**PLANNED UNIT DEVELOPMENT &
SIDEWALK WAIVER REQUEST
STAFF REPORT**

Date: February 21, 2008

Valenti Southeast Realty

3215 Airport Boulevard
(South side of Airport Boulevard, extending to the North
side of Airport Boulevard Service Road, 670'+ West of Bel
Air Boulevard)

SITE PLAN

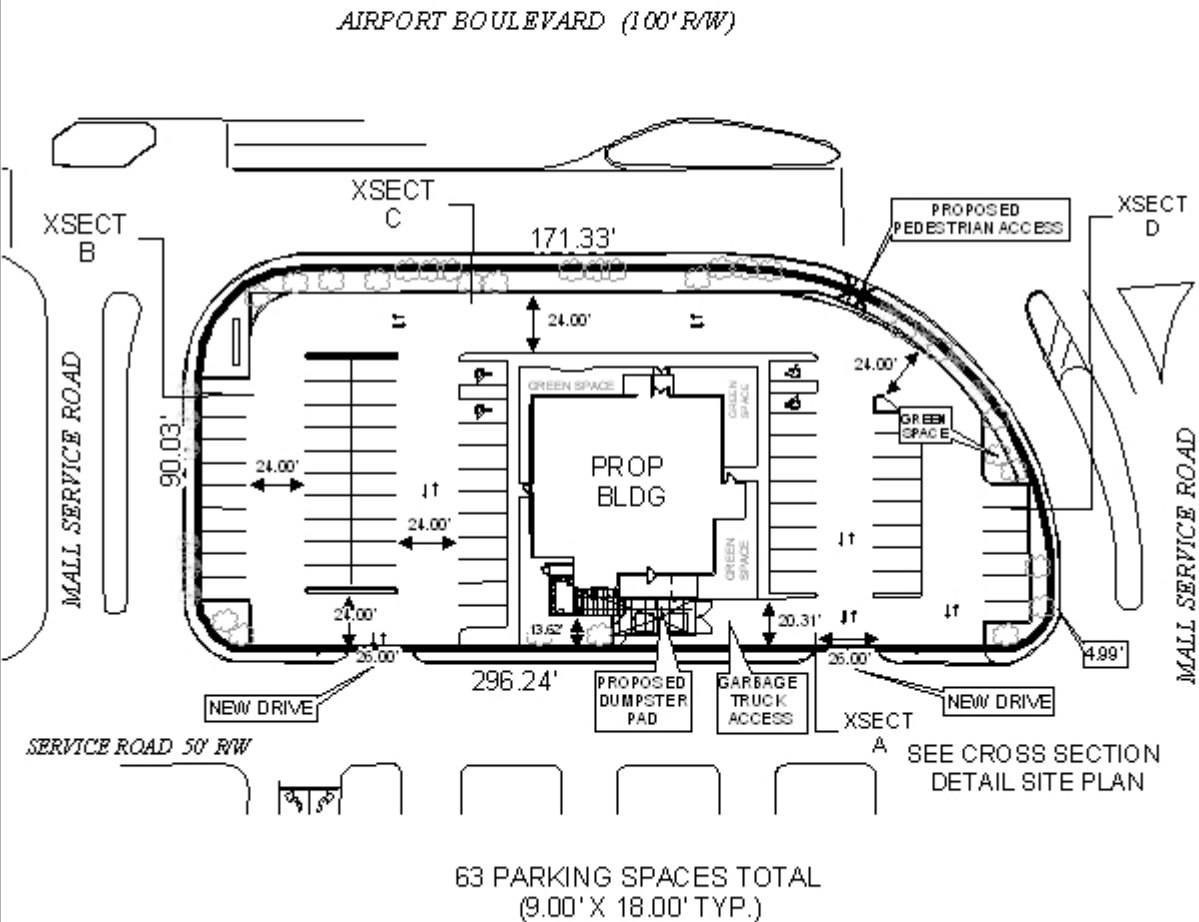
The applicant is requesting a reduction in the required 25-foot building setback along the southern boundary to accommodate the proposed 6,270 square foot restaurant. The main portion of the building will be approximately 13 feet from the southern property boundary, however, the enclosure for the dumpsters will be only 6 feet from the southern property boundary. The site plan should be revised to depict a 25-foot minimum building setback line from all street frontages, except for where the site plan depicts the building and dumpster enclosure encroaching upon the normal setback.

It also appears that some of the curbing associated with the parking area may cross the property boundary on the South and West sides. Any new construction must take place fully within the property, with the exception of the proposed pedestrian access to Airport Boulevard.

The site plan depicts the building and 63 parking spaces, with 3 additional spaces provided for motorcycles. Interior circulation appears to meet minimum dimensional requirements as it relates to the width of access aisles, but the layout of the parking does not appear to provide much accommodation for vehicular turning radii, thus setting the stage for congestion and accidents on the site during parking maneuvering and circulation – thus the site may be being overbuilt. The congestion caused by the site design may result in back-ups into adjacent roads. The number of parking spaces, however, does meet the minimum quantity requirements for the restaurant.

Calculations are provided for the landscape area, and it appears that the total area will exceed the minimum requirements of the Zoning Ordinance. Additional landscape area, thus additional area for tree planting, can be provided by curving the corners of the parking area where the original curb-cuts are being eliminated, and by replacing the proposed motorcycle parking spaces with landscape areas. A tree plan depicts a sufficient quantity of trees to meet the frontage requirements, and appears to provide additional extra overstory trees within the lot interior, however, three (3) additional understory trees may be required for the parking lot requirements. The palm trees that exist around the perimeter of the site appear to either be on the site or to straddle the property line: if on the site, they can count towards meeting the frontage tree requirement. Full compliance with the tree requirements of the Zoning Ordinance should be coordinated with Urban Forestry.

- 1) The site is limited to two curb-cuts to the Airport Boulevard Service Road to align with the parking aisles located immediately next to the proposed restaurant, and the site plan should be revised to adjust the Western curb-cut to align with the parking aisle, with the size and design to be approved by Traffic Engineering and to conform with AASHTO standards;
- 2) Existing curb-cuts are to be removed and landscaped to match adjacent right-of-way;

- 3) The site is denied any curb-cuts onto to Airport Boulevard;
- 4) Revision of the site plan to depict the 25-foot minimum building setback line along all street frontages, except where the building and dumpster will encroach upon the setback – the setback line to follow the building and dumpster enclosure as depicted, not to be less than 6-feet from the property line;

- 6) Revision of the site plan to ensure that all parking and new curbing for the parking areas occurs within the boundaries of the site, and that vehicles will not overhang the property boundaries – installing wheel stops as necessary;

- 7) Coordination with Urban Forestry regarding compliance with the tree requirements of the Zoning Ordinance;
- 8) Revision of the site plan to provide additional landscape area by curving the parking area where the original curb-cuts are eliminated, and consideration of replacing the motorcycle parking spaces with additional landscape area; and

CROSS SECTION DETAIL #1

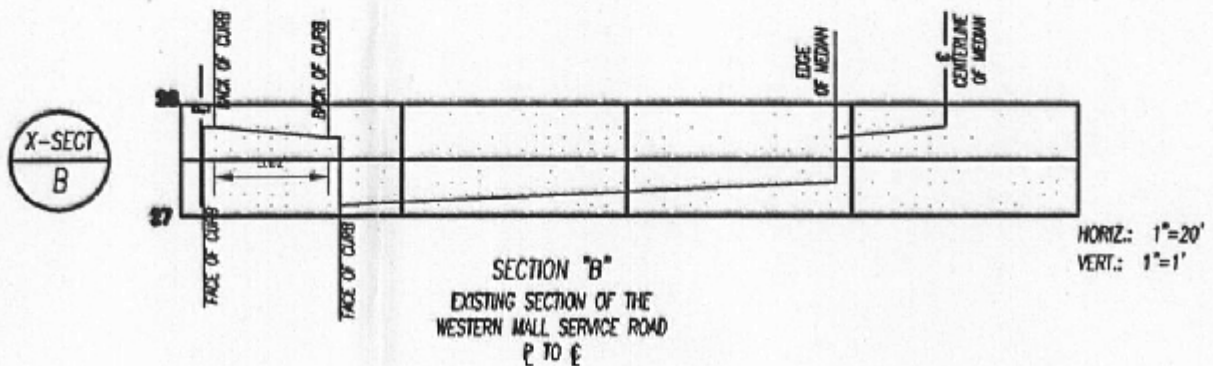
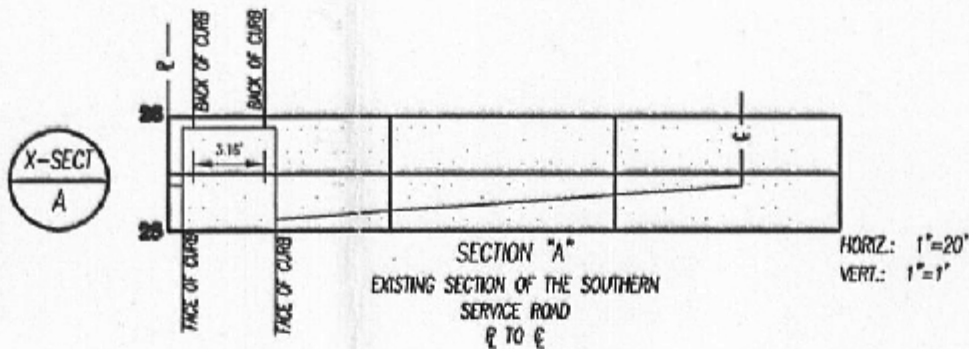
Must comply with all storm water and flood control
ordinances. Any work performed in the right of way will require a right of way permit. Based
on information provided by the applicant, it appears that the lack of space between the back of
curb and property line would prevent the construction of City standard sidewalk.
